**RAIs 1, 2 and 3 Responses for  
PWROG-16043, Revision 2**

**(PA-ASC-1169) (Non-Proprietary)**

## RAI 1

Figure 4. Example of Grid Impact

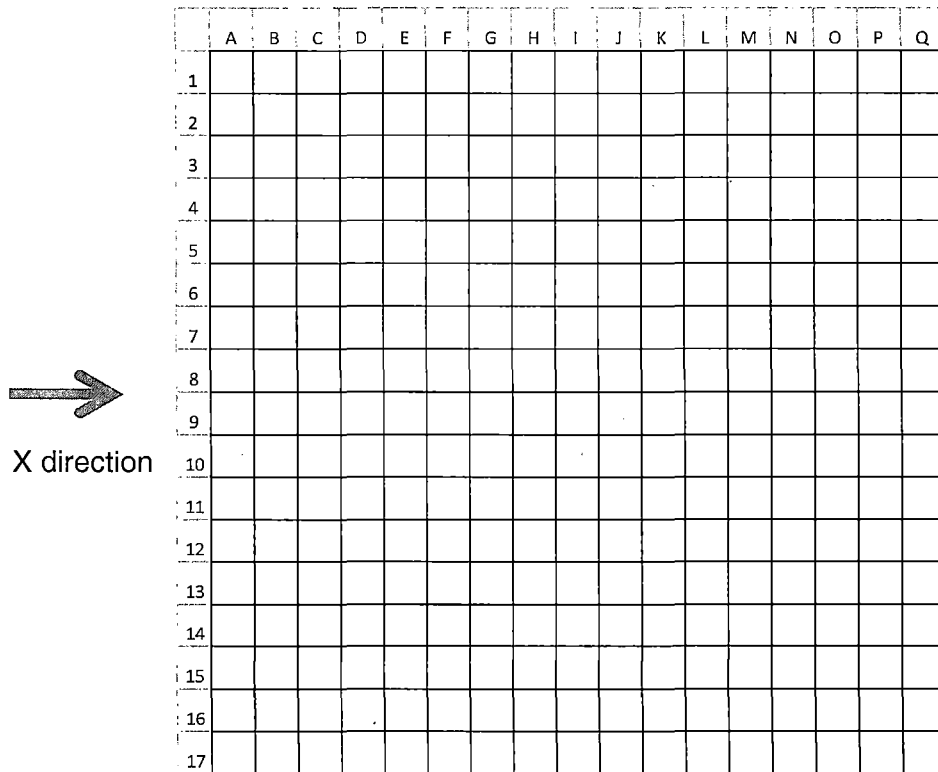
c. "how this may impact the spacer grid structural behavior"

The grid impact occurs on the grid side surfaces. For example, a grid is impacted in the X direction as shown in Figure 4. The impact force is shared by the whole column A (from cell A1 to cell A17) and is transferred to the whole grid through all columns (from Column A to Column Q). Therefore, the cell gap size differences in a grid would have a small impact on the overall structural behavior of a spacer grid.
